Entergy Nuclear Operations, Inc.
Palisades Nuclear Plant
27780 Blue Star Memorial Highway
Covert, MI 49043
Tel 269 764 2000

PNP 2011-016

SUBJECT: License Amendment Request for Primary Coolant System
Pressure-Temperature Limits

Palisades Nuclear Plant
Docket 50-255
License No. DPR-20

Figure 3.4.3-1 (Page 1 of 1)
Pressure – Temperature Limits for Heatups
Applicable up to 42.1 EFPY

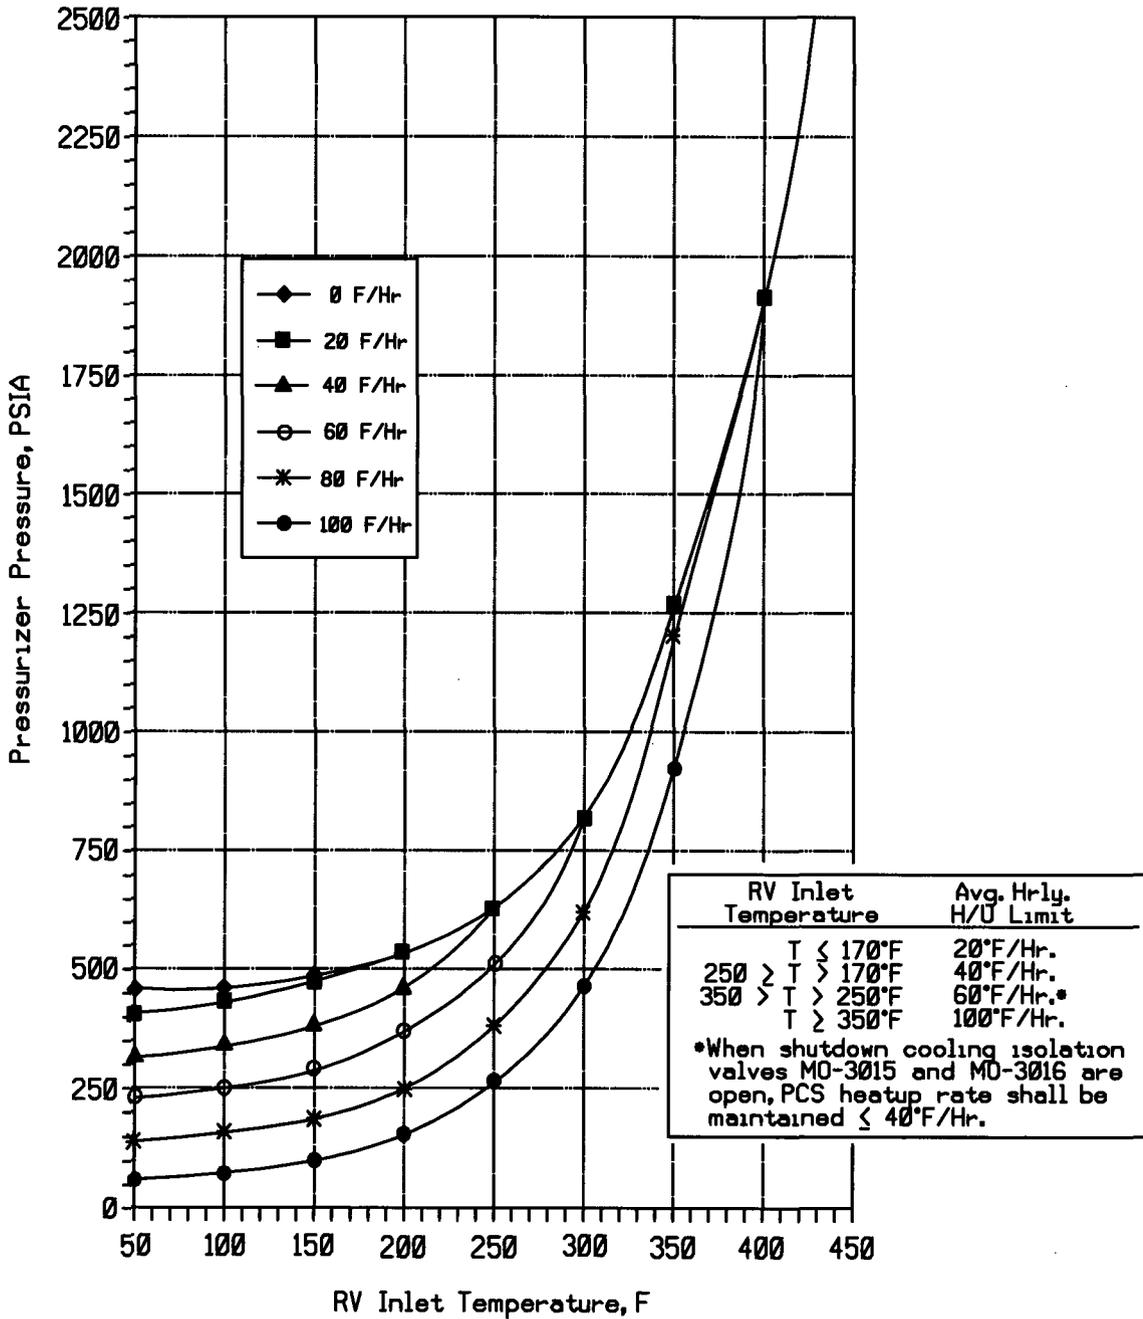
The proposed change revises the figures referenced in LCO 3.4.3 and LCO 3.4.12 by adding the applicability period of 42.1 EFPY to Figure 3.4.3-1, “Pressure – Temperature Limits for Heatups,” Figure 3.4.3-2, “Pressure – Temperature Limits for Cooldown,” and Figure 3.4.12-1, “LTOP Setpoint Limit.”

The proposed changes revise the TS by adding the applicability period of 42.1 effective full power years (EFPY) to Limiting Condition of Operation (LCO) 3.4.3 Figure 3.4.3-1, "Pressure – Temperature Limits for Heatups" and Figure 3.4.3-2, "Pressure – Temperature Limits for Cooldown."

Figure 3.4.12-1 (Page 1 of 1)
LTOP Setpoint Limit
Applicable up to 42.1 EFPY

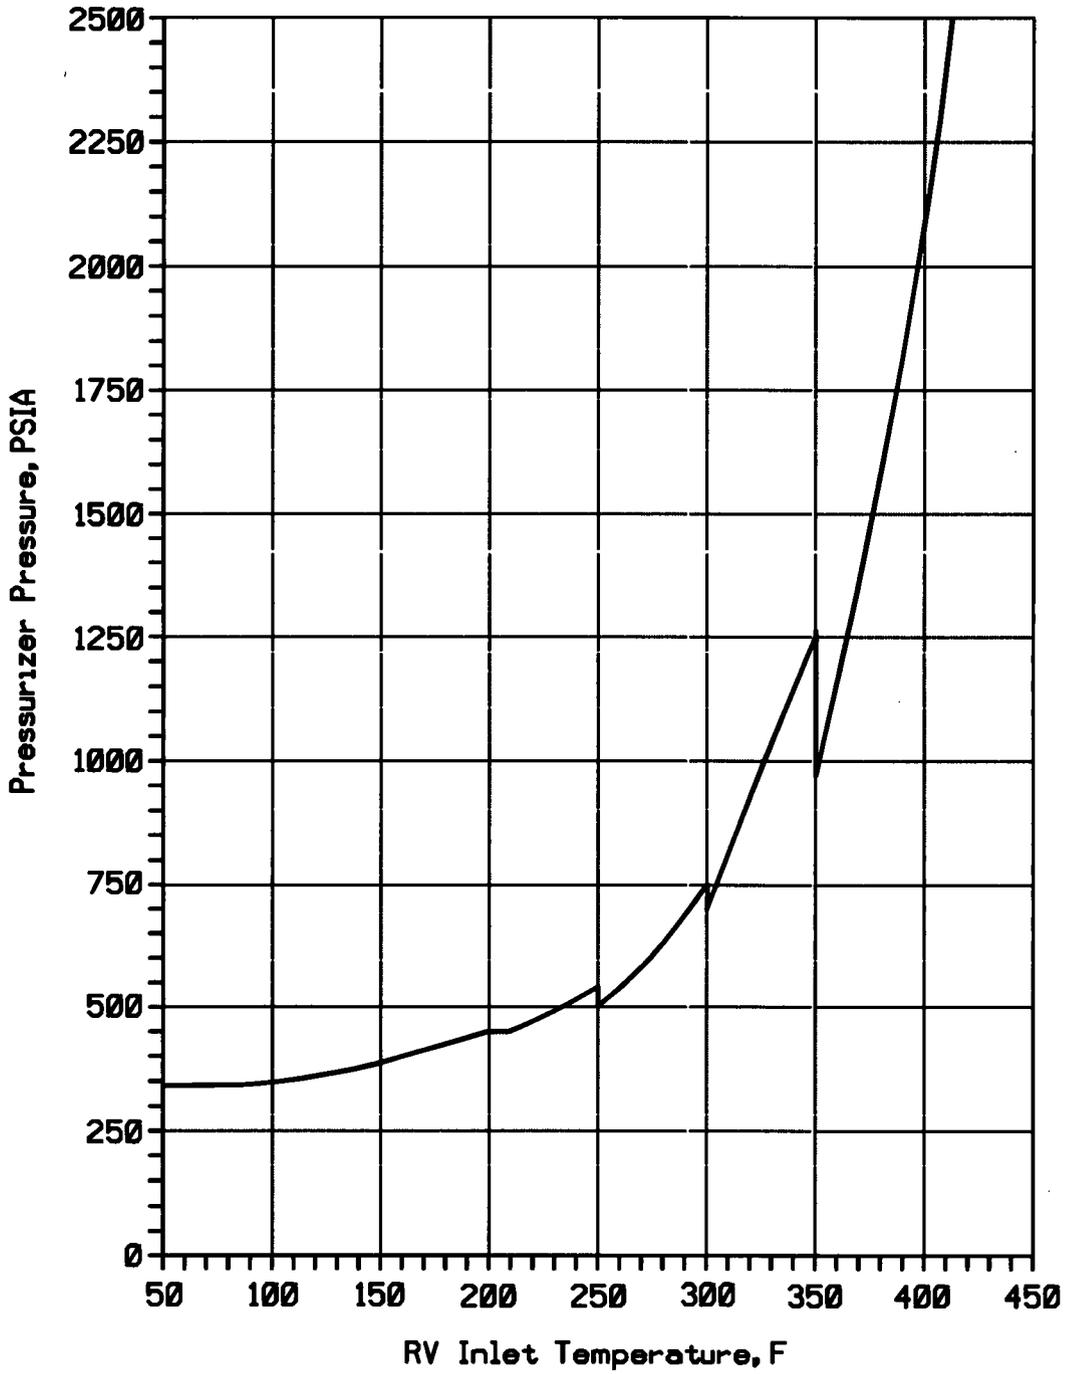
The 42.1 EFPY applicability period is also added to LCO 3.4.12 Figure 3.4.12-1, "LTOP Setpoint Limit."
